COVER SHEET  
FOR  
**PUYALLUP PUBLIC SAFETY BUILDING**

PRCCP20030372  
1st Review  
May 2025

COVER SHEET  
FOR PUYALLUP PUBLIC  
SAFETY BUILDING BENAROYA  
TENANT IMPROVEMENT PERMIT/BID SET

A PORTION OF THE NE 1/4, SE 1/4, NW 1/4 & SW 1/4, OF THE SE 1/4 OF SEC. 3, TWN. 19 N, RGE. 4 E, W.M. CITY OF PUYALLUP, PIERCE COUNTY, WASHINGTON

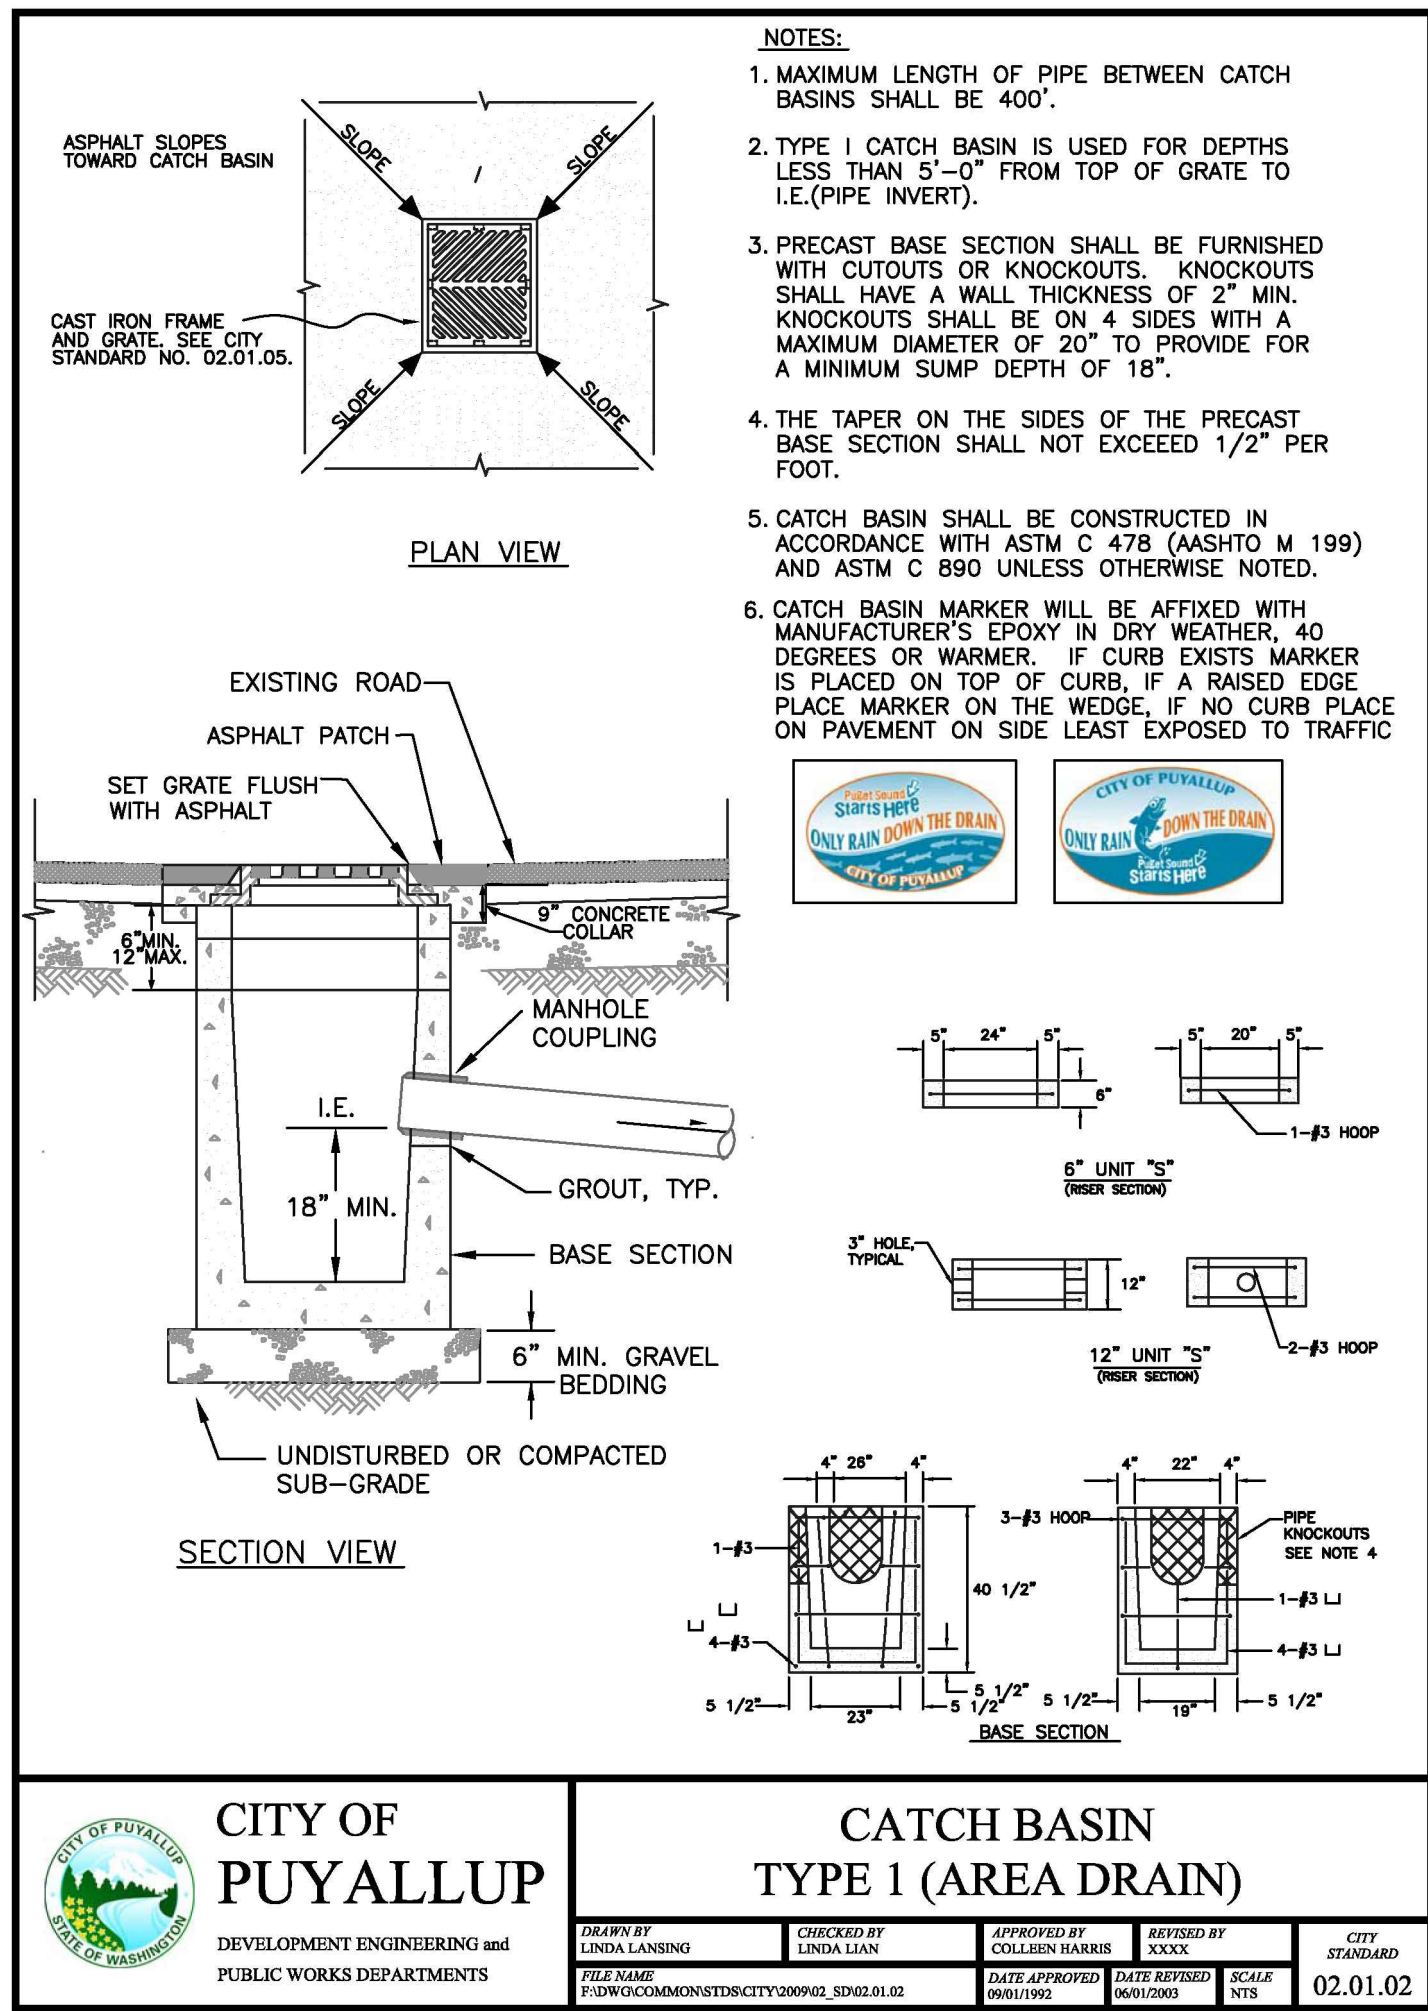
Add City Standard Details:  
06.01.02

DETAIL  
ADDED
